Addendum 62 : Regulation No. 63

Amendment 1

01 series of amendments - Date of entry into force: 8 March 1999

UNIFORM PROVISIONS CONCERNING THE APPROVAL OF TWO-WHEELED MOPEDS WITH REGARD TO NOISE

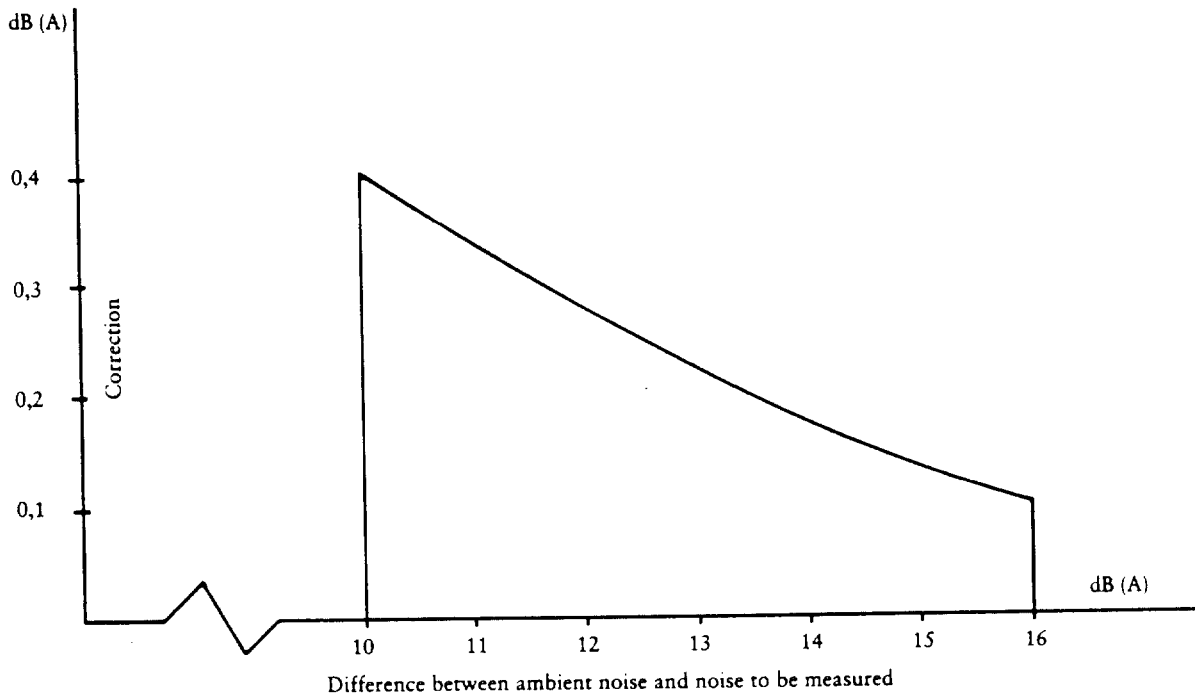
Paragraph 2.1.3., amend to read:

For measurement purposes, the weighted sound-level (A) of sound sources on the test vehicle and the sound-level produced by the effect of the wind shall be at least 10 dB(A) below the noise-level produced by the vehicle. The microphone may be fitted with a suitable wind guard, provided that its influence on the sensitivity and directional characteristics of the microphone are taken into account.

If the difference between ambient and measured noise-levels is between 10 and 16 dB(A), the appropriate figure shall be subtracted from the value recorded by the sound-level metre, in accordance with the following graph:

Figure 3

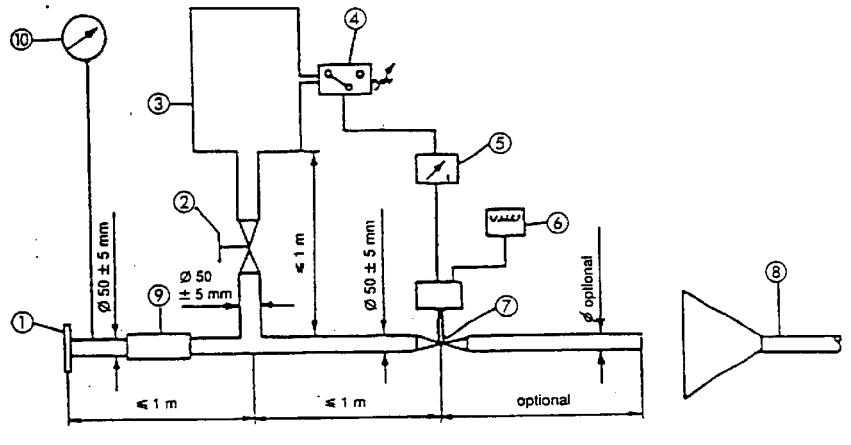
Insert a new figure 3 as follows:

"TEST APPARATUS FOR CONDITIONING BY PULSATION

1. Inlet flange or sleeve for connection to the rear of the test exhaust system.

2. Hand-operated regulating valve.
3. Compensating reservoir with a maximum capacity of 40 l and a filling time of not less than one second.
4. Pressure switch with an operating range of 0.05 to 2.5 bar.
5. Time delay switch.
6. Pulse counter.
7. Quick-acting valve, such as exhaust brake valve 60 mm in diameter, operated by a pneumatic cylinder with an output of 120 N at 4 bar. The response time, both when opening and closing, must not exceed 0.5 seconds.
8. Exhaust gas evacuation.
9. Flexible pipe.
10. Pressure gauge."

Minimum requirements for test surface area.
 The shaded part is called "Test Area".

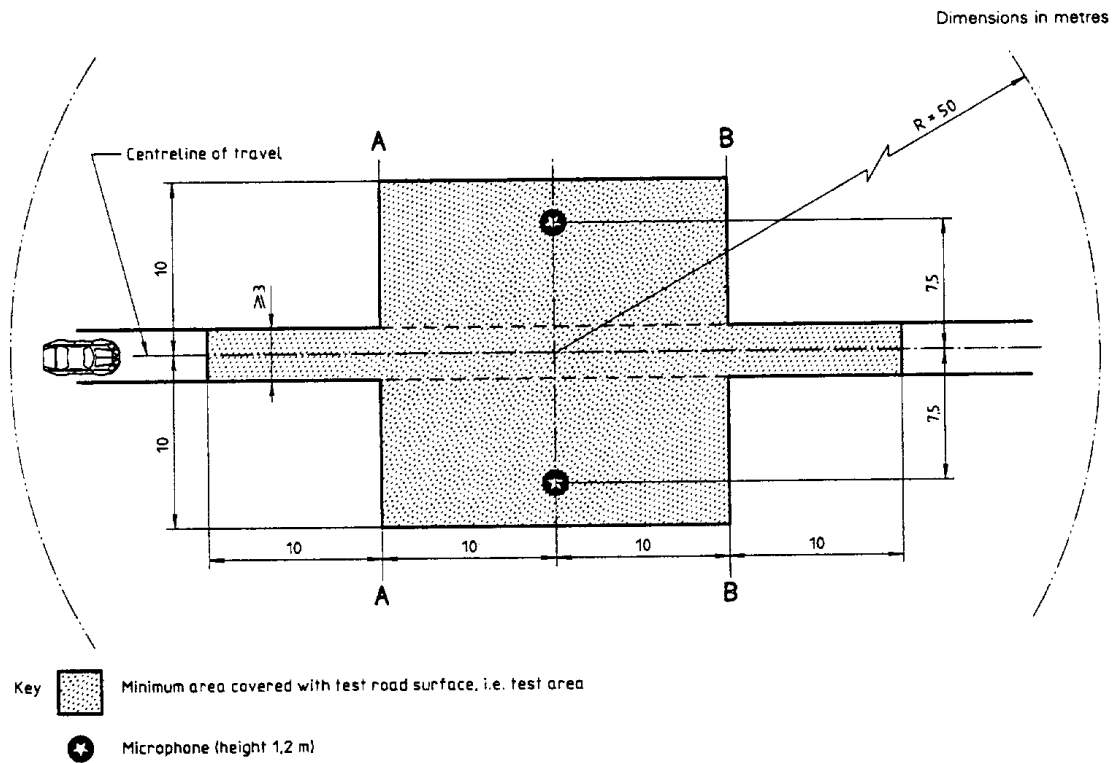
When designing the test track layout it is important to ensure that, as a minimum requirement, the area traversed by the vehicles running through the test strip is covered with the specified test material with suitable margins for safe and practical driving. This will require that the width of the track is at least 3 m and the length of the track extends beyond lines AA and BB by at least 10 m at either end. Figure 1 shows a plan of a suitable test site and indicates the minimum area which shall be machine laid and machine compacted with the specified test surface material. According to annex 3, paragraph 3.1.1.1., measurements have to be made on each side of the vehicle. This can be made either by measuring with two microphone locations (one on each side of the track) and driving in one direction, or measuring with a microphone only on one side of the track but driving the vehicle in two directions. If the former method is used, then there are no surface requirements on that side of the track where there is no microphone.

NOTE — There shall be no large acoustically reflective objects within this radius.

Figure 2: Grading curve of the aggregate in the asphaltic mix with tolerances.

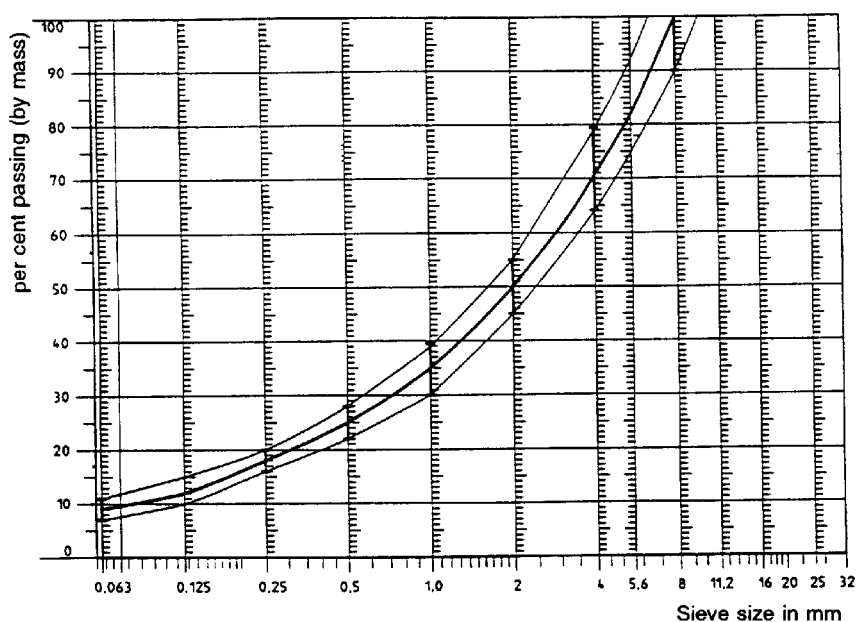
As a guide to the surface constructor, an aggregate grading curve

which will give desired characteristics is shown in Figure 2. In addition, Table 1 gives some guidelines in order to obtain the desired texture and durability. The grading curve fits the following formula:

$$P (\% \text{ passing}) = 100 \cdot (d/d_{\max})^{1/2}$$

where: d = square mesh sieve size, in mm
 $d_{\max} = 8 \text{ mm}$ for the mean curve
 $d_{\max} = 10 \text{ mm}$ for the lower tolerance curve
 $d_{\max} = 6.3 \text{ mm}$ for the upper tolerance curve
